(III) ACTION AGENDA

(1) SP2025-032 (HENRY LEE)

CASE NUMBER: SP2025-032; Site Plan for 855 Whitmore Drive

APPLICANT: Dub Douphrate; Douphrate and Associates **CASE NUMBER:** SP2025-033; Site Plan for Timpa Law Office

ELEVATIONS

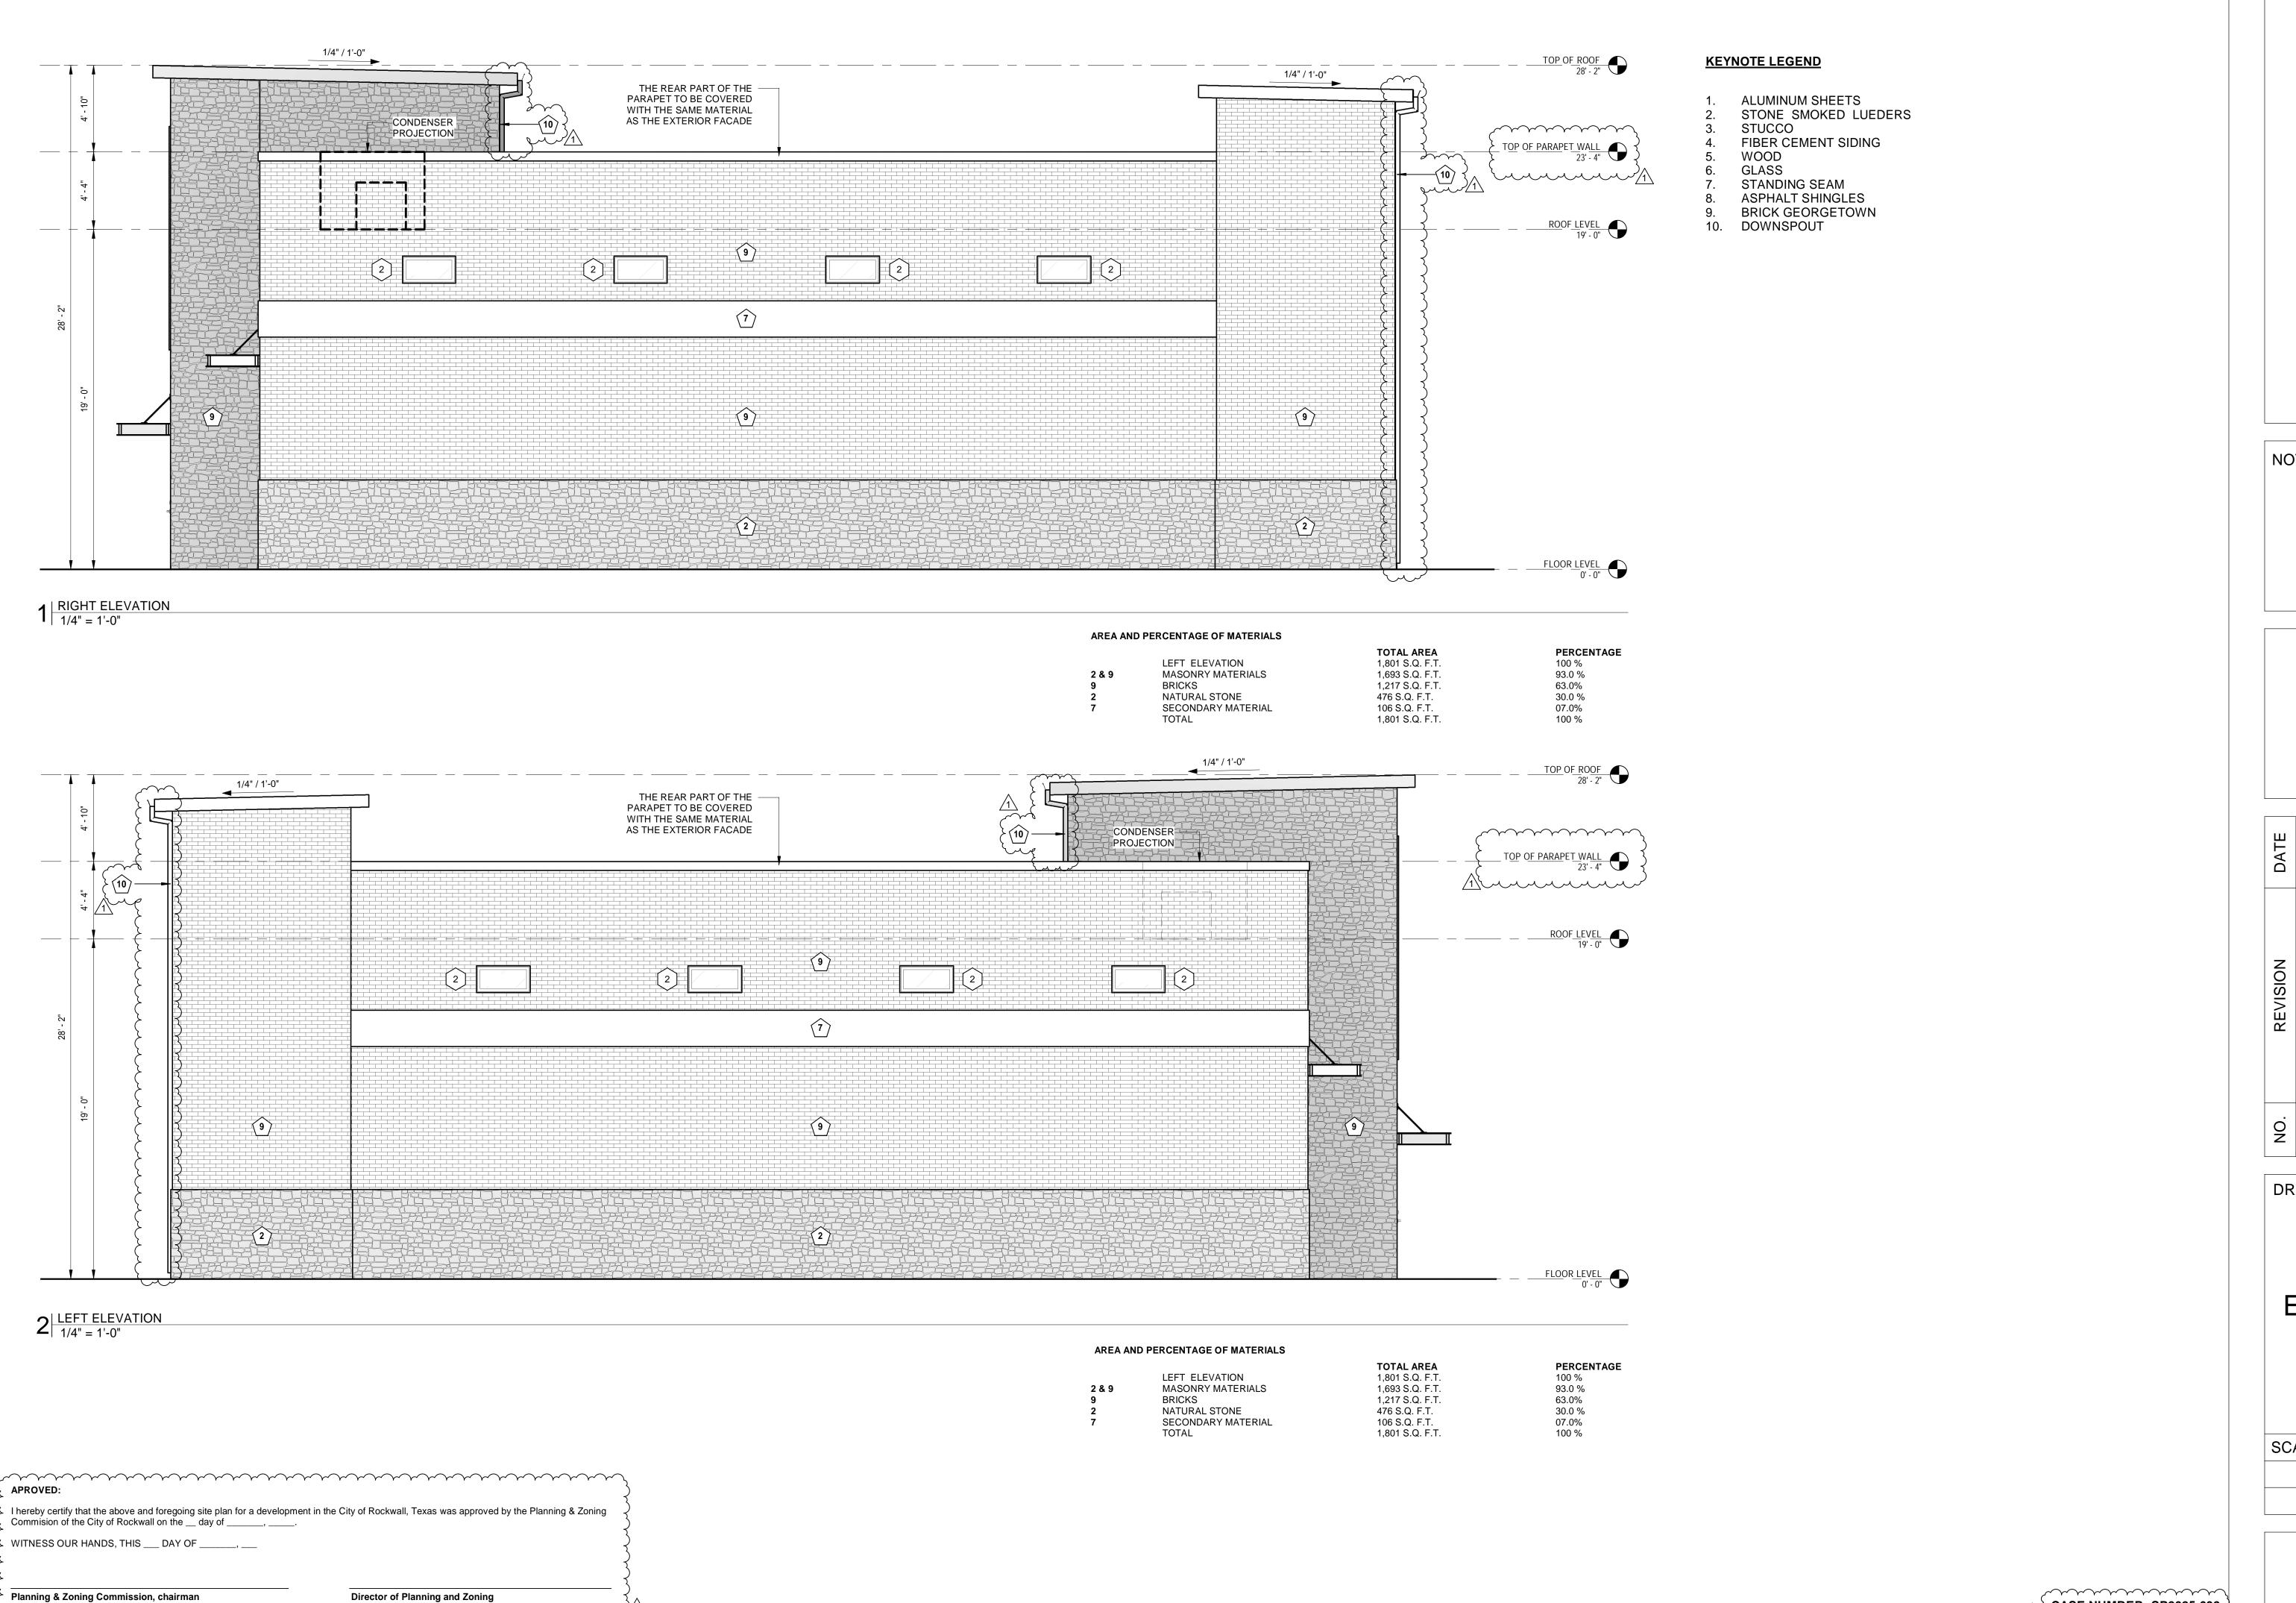
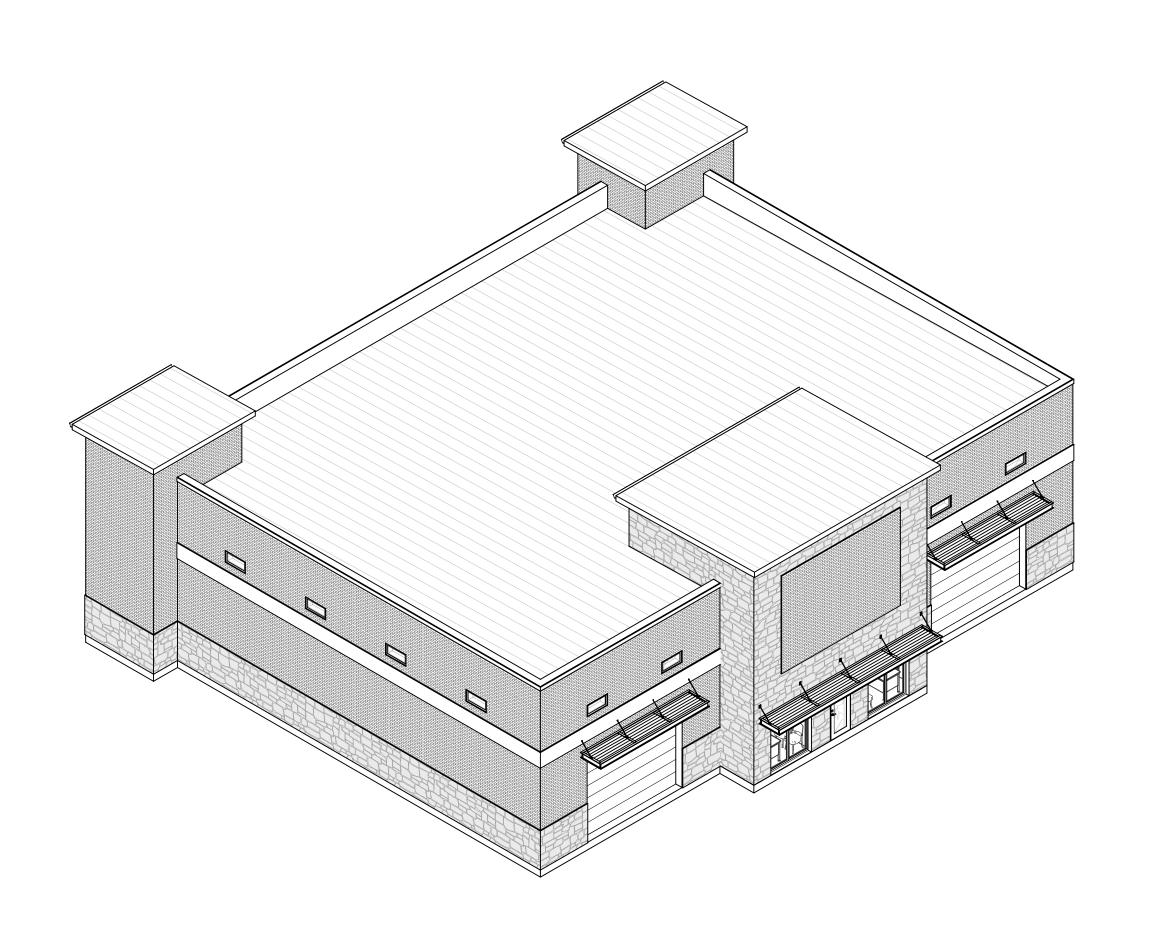
- (2) <u>Articulation</u>. According to Subsection 01.05, General Industrial District Standards, of Article 05, District Development Standards, of the Unified Development Code (UDC), all industrial buildings shall meet the primary and secondary articulation requirements outlined in Figure 13, Industrial Building Articulation Standards, of Article 05, District Development Standards, of the Unified Development Code (UDC). In this case, the primary façade facing onto Whitmore Drive, does <u>not</u> meet the primary articulation standards. This will require and <u>exception</u> from the Planning and Zoning Commission.

On July 29, 2025, the Architectural Review Board (ARB) reviewed the proposed building elevations and made the recommendations that the bay doors be moved to the side or rear of the building, and to include additional store front glass on the front of the building. The applicant has <u>not</u> incorporated the requested changes. The Architectural Review Board (ARB) will review the updated building elevations prior to the <u>September 30, 2025</u> and provide a recommendation to the Planning and Zoning Commission.
